Geotechnical aspects of Kielder Dam

J. P. Millmore and R. McNicol

DISCUSSION

Fig. 24. (a) Vertical stress values at the John Martin Dam; (b) position of piezometer B54 at Kielder

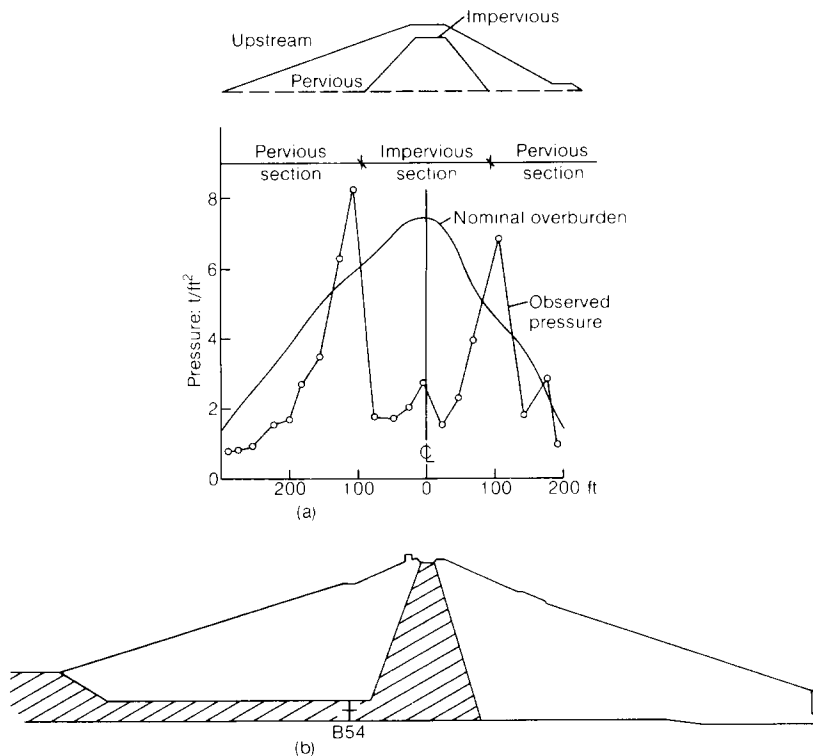
The pore pressures found by the Authors were exceptional. The ratio pore pressure/overburden pressure r_u of 10.7 obtained from piezometer B54 (§ 27) is remarkably high. In 1951, I measured r_u values of 1.8 in the fill of Usk Dam^{1,2} but this was due to use of a coarse intake filter that allowed the piezometers to measure the pressure of air in the voids of the fill rather than pore water pressure.

59. If it is assumed that the measured value of r_u is greater than 1, this may be accounted for by an increase of vertical stress above the overburden value caused by arching. Measured values of vertical stress at the John Martin Dam (Fig. 24)

reveal a considerable increase of vertical stress in the fill on either side of the core. Piezometer B54 was in a region where this action could have caused a vertical stress at Kielder greater than the overburden.

102. The possibility of measuring pore air pressure in the piezometers was referred to by *Dr Penman*. The modern ceramic tips to which he referred were used to overcome such problems at Kielder and the piezometers were de-aired when necessary. More than 70 m head was measured at piezometer B54 and at this pressure of water, any air was likely to be fully dissolved. We did not experience any difficulty with the read-out apparatus. The calibration of all equipment was regularly checked to account for minor drifting that occurs on all such equipment. We consider that a reading frequency of once every two days was sufficient to restore equilibrium of the piezometer/fill system. The rate of earth filling made it unnecessary to read the piezometers more frequently.

104. *Dr Penman* and *Mr Ruffle* both agreed that the B values greater than 1.0 in the blanket were most likely a consequence of the stress transfer within the dam. The pattern of stress transfer at Kielder Dam can be seen from the piezometric profile shown in Fig. 20. The difference between this profile and that at John Martin Dam described by *Dr Penman* is most likely related to the internal geometry and soil parameters at both sites. The piezometric values in all piezometers within Kielder Dam were plotted continually and estimates of the final pore pressures within the dam were made regularly. On the basis of these, there was never concern that the stress transfer would be such that the pore pressures within the core would be lower than the reservoir top water level. Hence there was no concern about hydraulic fracture of the core. These predictions of the final piezometric values were also used in the monitoring of the stability of the dam during construction.

Fig. 25. Relationship between shear strength and moisture content for typical materials in Sandboard Knowe borrow pit

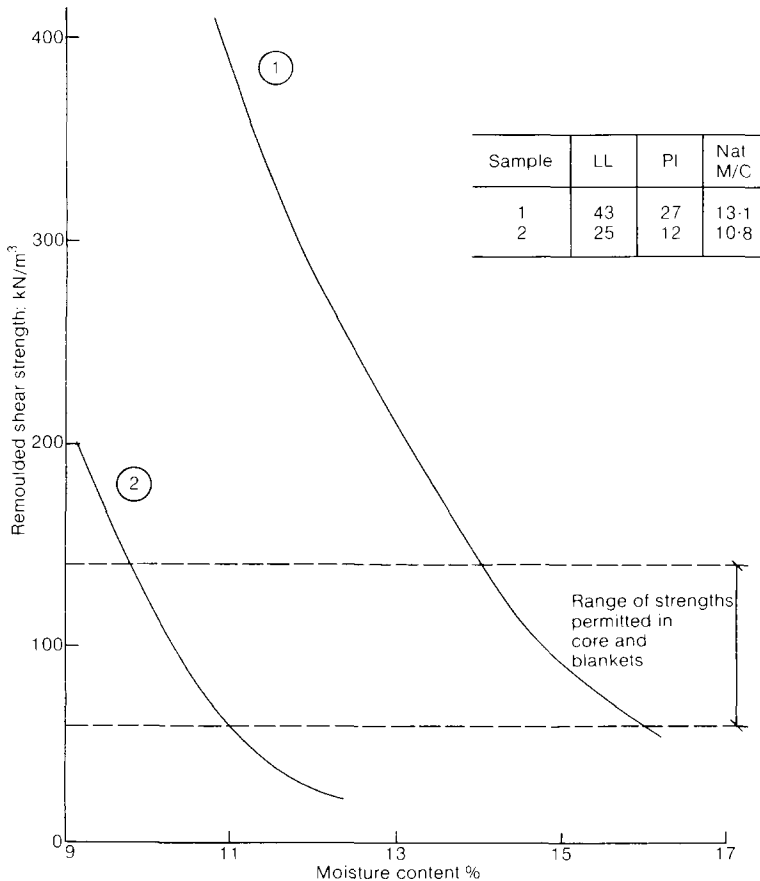
71. Problems were also met with the thick overburden of soft unusable material. In some cases about 5 m of very soft unusable material had to be taken to tip, and below that some fairly soft glacial till occurred. Fig. 11 shows the differing shear strength moisture content relationships that are present in Sandboard Knowe. Fig. 25 shows typical relationships. Sample 1 is a very sandy till, with a fairly steep shear strength moisture content relationship, and Sample 2 is a much more cohesive till. There is a much wider moisture content range for the core with

the more cohesive till than there is with the very sandy till, 2% compared with 1.2%. Both these materials were present in Sandboard Knowe mixed together, and it was very difficult to select one from the other.

Fig. 26. In situ shear strength against moisture content in Sandboard Knowe borrow pit

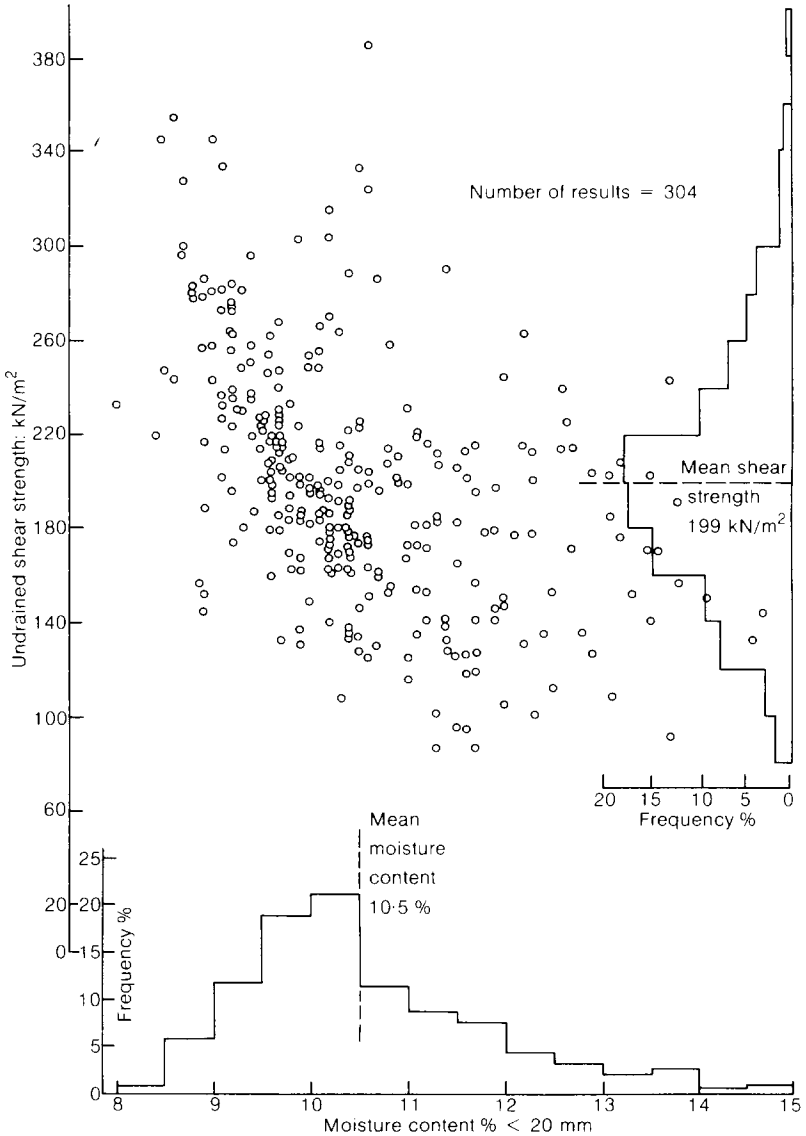
72. Figure 26 shows the range of in situ strengths in Sandboard Knowe, and the range of moisture contents. Both covered an enormous range, and there was no clear relationship between shear strength and moisture content. Because of these large differences in material type, some means had to be found to select materials best suited for either the core or shoulder of the dam. After a great deal of laboratory testing of materials taken from the borrow pit, the joint venture decided to place the more cohesive tills in the core and to place the dry sandier tills in the shoulders of the dam. All wet sandy tills were discarded as unusable.

78. The glacial tills at Pea Croft were more consistent than those excavated at Sandboard Knowe with a much more uniform shear strength/moisture content relationship as can be seen from comparing Figs 26 and 27. As a result it was

Fig. 27. *In situ shear strength against moisture content in Pea Croft borrow pit*

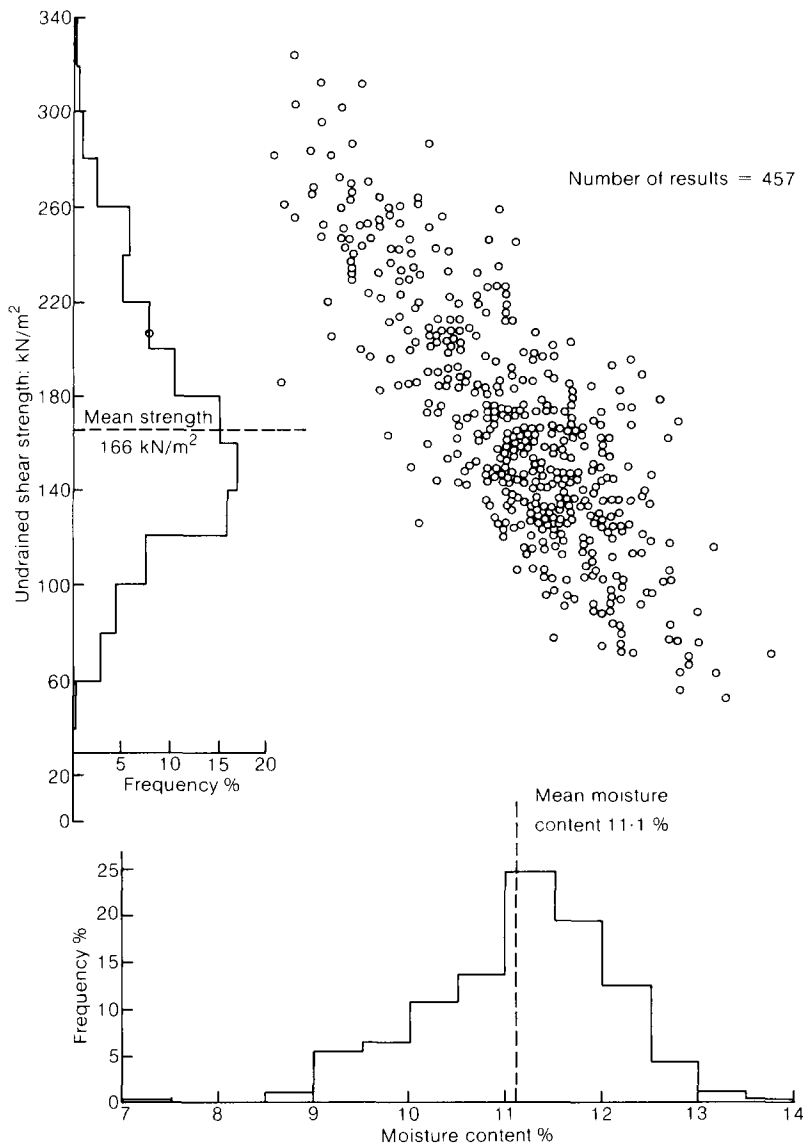
possible to use motor scrapers in Pea Croft and thus speed up the operation. Also the control of shear strength was much easier and this and changes in testing method allowed very high rates of compliance to be achieved.

Fig. 28. Undrained shear strengths for core material excavated from Pea Croft borrow pit between 16 August 1979 and the end of 1980

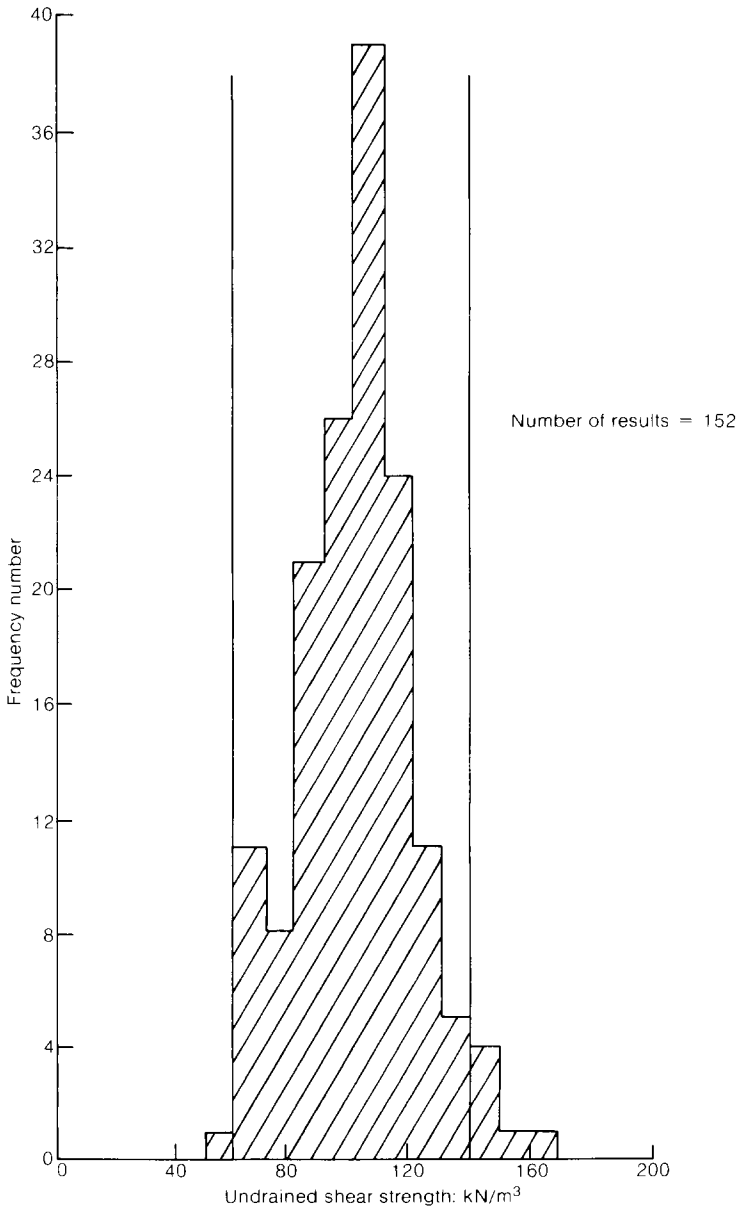
79. Tests carried out between ourselves and Sandberg, for the core using remoulded tests, are shown in Fig. 28. Similarly, the results for the shoulder of the

Fig. 29. Undrained shear strengths for shoulder material excavated from Pea Croft borrow pit in 1980

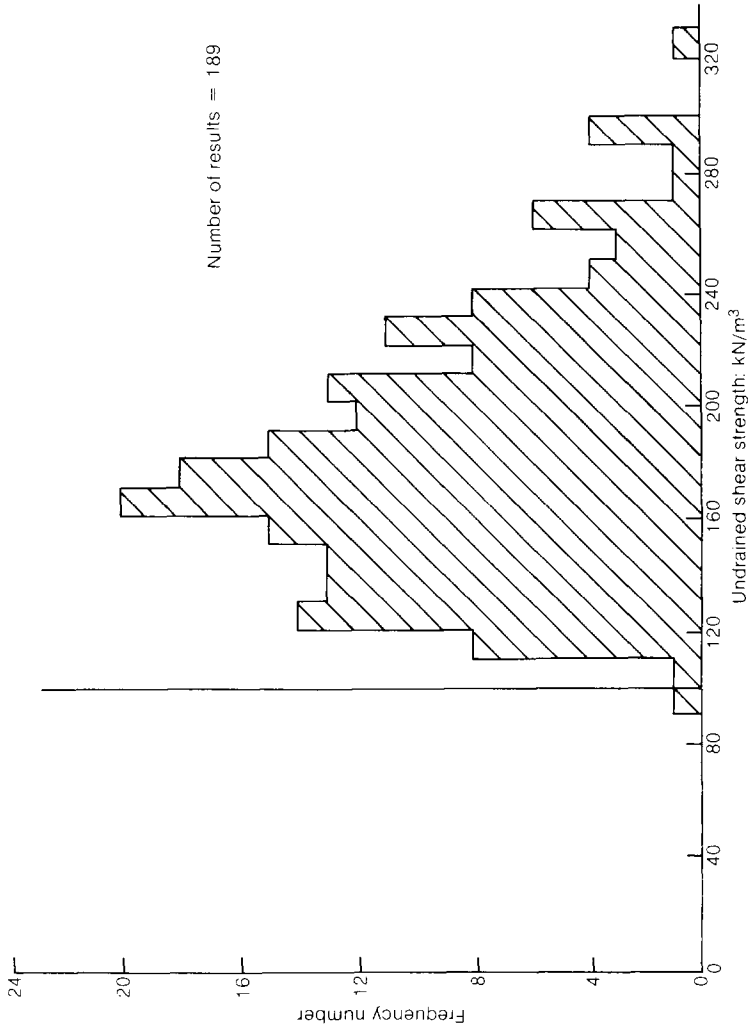
dam, for Pea Croft material excavated and placed in 1981, show almost 100% compliance with the specification (Fig. 29).

Fig. 30. Cross-section of Kielder Dam showing the core and blanket piezometers: (a) south end of dam; (b) intermediate section (c) river valley

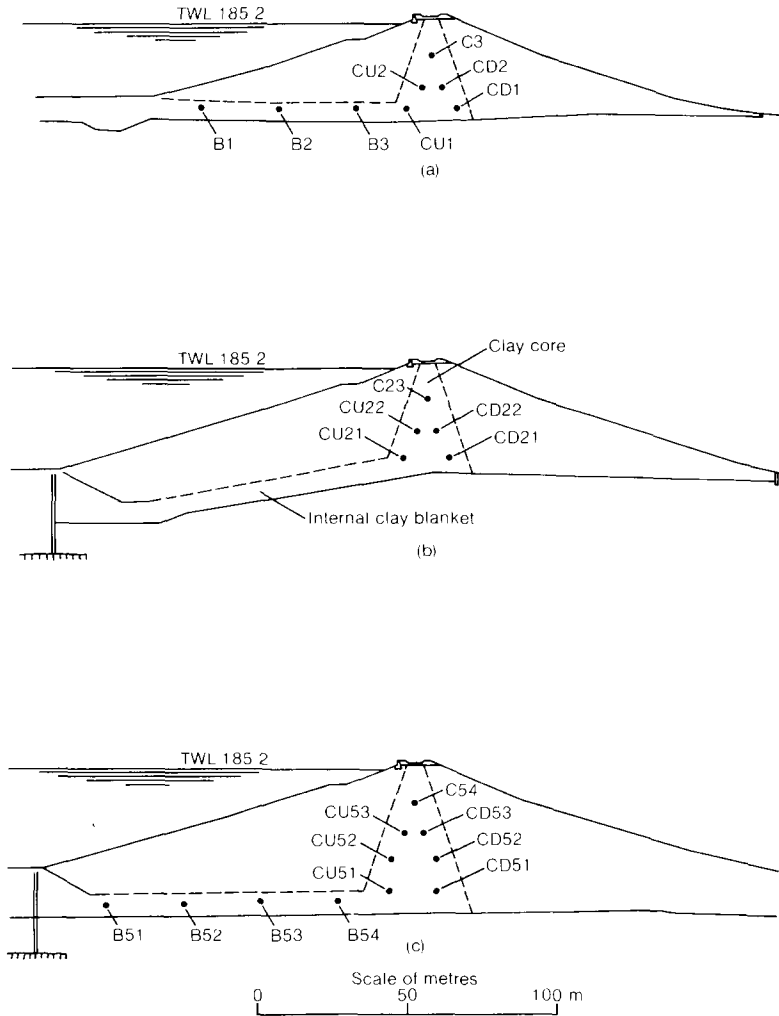
103. Most of the piezometers in the core and blanket shown in Fig. 30 indicated high pressures. However, the pore pressure at piezometer B54 was the highest measured in any piezometer in the embankment. Table 11 summarizes the maximum pore pressure values for all piezometers in the core and blanket during the final earth-filling season. From this table it can be seen that the pore pressure ratio r in piezometer B54 was 0.8, not 1.7, as indicated by *Dr Penman*. Paper 8703 stated that it was the ratio of increase in pore pressure to increase in weight of earth fill (B) which reached 1.7. As *Mr Ruffle* indicated, the B values measured at piezometers CU51 and CU52 were not as high as in piezometer B54. However, the pore water pressures in both piezometers were high and CU51 was only slightly lower than the adjacent B54.

105. The thickness of the clay blanket no doubt did contribute to the high pore

pressures as suggested by *Mr Kennard*. The blanket thickness was initially selected as 6 m on the basis of laboratory test results. In situ parameters subsequently dictated a thinner blanket of 5 m. We did not wish to incorporate a rolled clay blanket any thinner than 5 m since this formed part of the impervious zone in the dam. With hindsight, it may have been appropriate to construct the clay blanket a little drier than the core material by specifying a higher strength for the soil. This would have produced lower pore pressures.
